Overview: Production error; immobilizer wire (orange/black) in pin position #4 instead of pin position #5. Although an effort to correct the issue was made, some quantity of harnesses did get shipped before the issue was spotted. We are advising to inspect the harness BLADE connector before attempting to install the harness and program the module.

Overview: The FTI-STP1 harness may require modification for use in **automatic transmission (AT)** applications, some of the product was able to be modified before release, but a small quantity was released before being able to be modified internally.

FTI-STP1: Installation and Configuration Notes

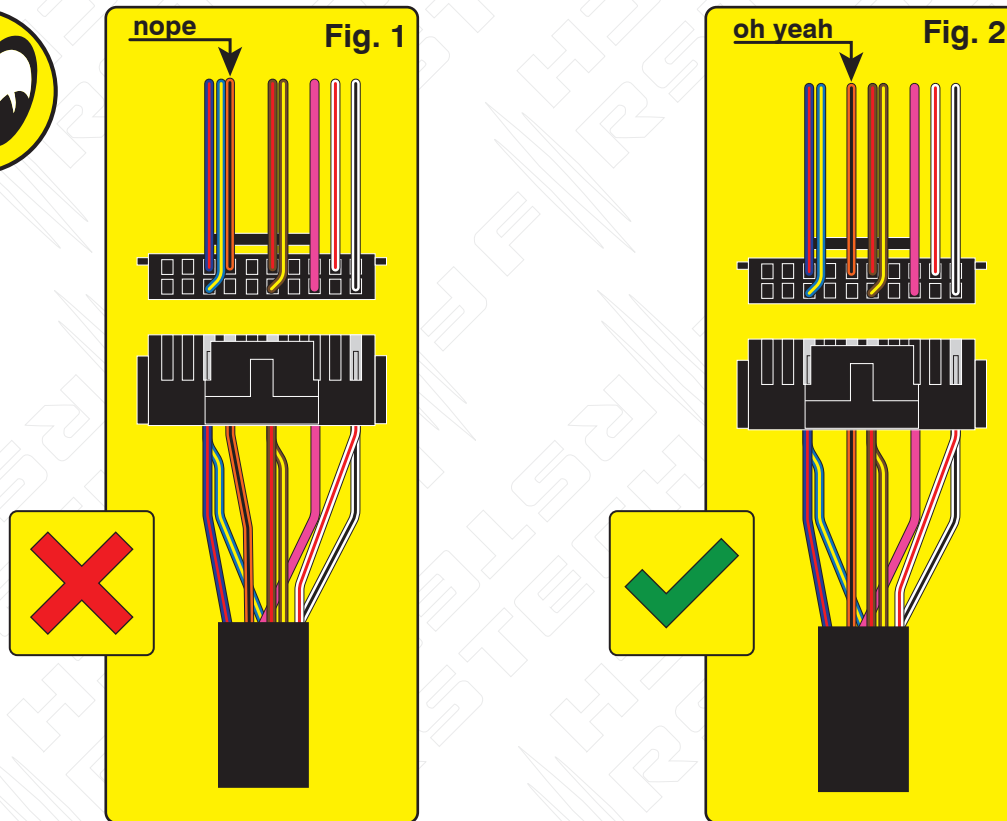
Issue: Module fails to program to vehicle, will not allow the vehicle to be remote started.

Correction: Step 1.) Locate the orange/black wire and confirm whether it is positioned as illustrated in Fig. 1 or Fig. 2. If the wire is as illustrated in Fig.1, proceed with Step 2 through 5 and complete the repair procedure outlined, if the wire is as illustrated in Fig. 2, correction is not necessary, proceed with harness installation and module programming.

Step 2.) Using a pick, lightly depress the catch that secures the terminal in the housing then remove the wire and terminal from the housing.

Step 3.) Using a fine tip razor or utility knife, insert the blade beneath the terminal catch and raise it slightly, so that it can be reused to secure the terminal when reinserted into the BLADE connector housing.

Step 4.) Refer to Fig. 2 for correct position of the orange/black wire (next to brown/red) then reinsert the terminal, pressing lightly until the catch 'snaps' into place, securing the terminal in the connector housing.

MODIFICATION REQUIRED FOR AUTOMATIC TRANSMISSION APPLICATIONS ONLY

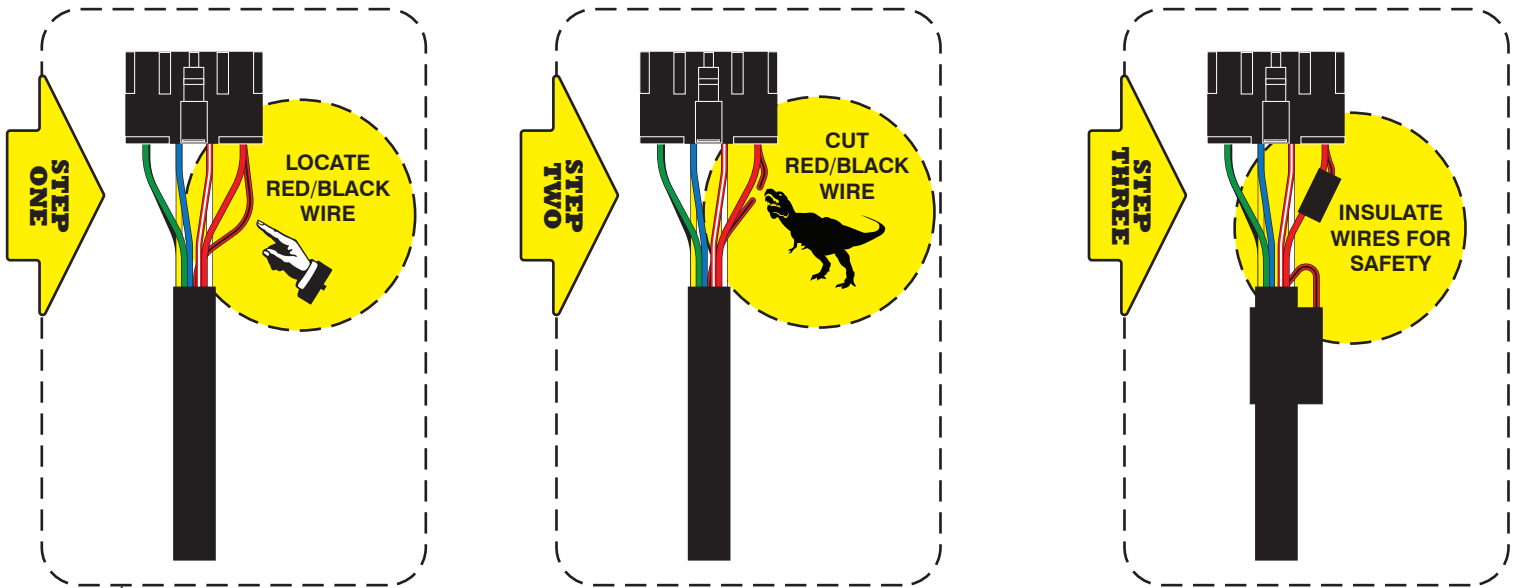
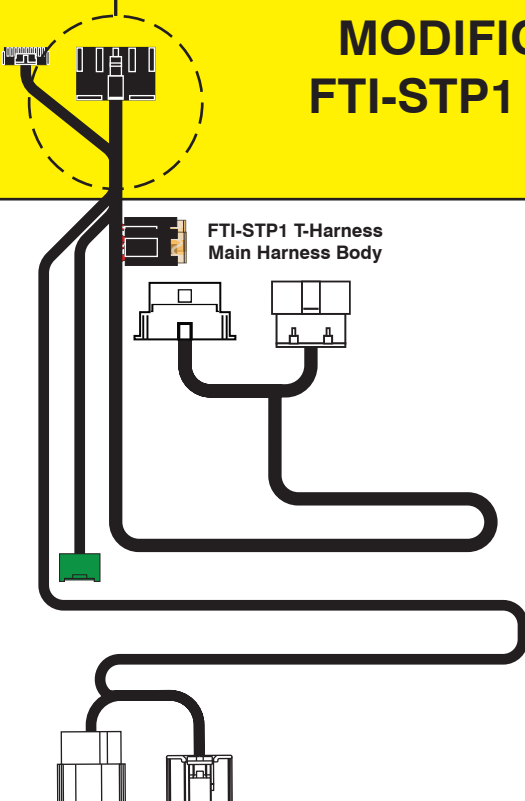
Issue: The FTI-STP1 T-harness has been designed to be compatible with AT (automatic transmission) & MT (manual transmission) applications, but due to a production oversight, the selection mechanism was defaulted to MT mode.

Using a harness configured for an MT application, in an AT equipped vehicle, could result in vehicle module damage, it is advised that the harness be returned to AT mode before installation in vehicles equipped with an automatic transmission.

Correction: Locate the **red/black (+ Clutch)** wire provided in the CN1 connector of the main harness assembly. Cut the **red/black** wire, either flush to the CN1 connector, or leaving enough wire exposed so that you can insulate and secure the ends of the wire that remain after cutting. Insulate each of the remaining ends of the **red/black** wire and secure to prevent any possibility of a short circuit.

If the red/black wire already been disconnected, no further modification is required for AT equipped vehicles.
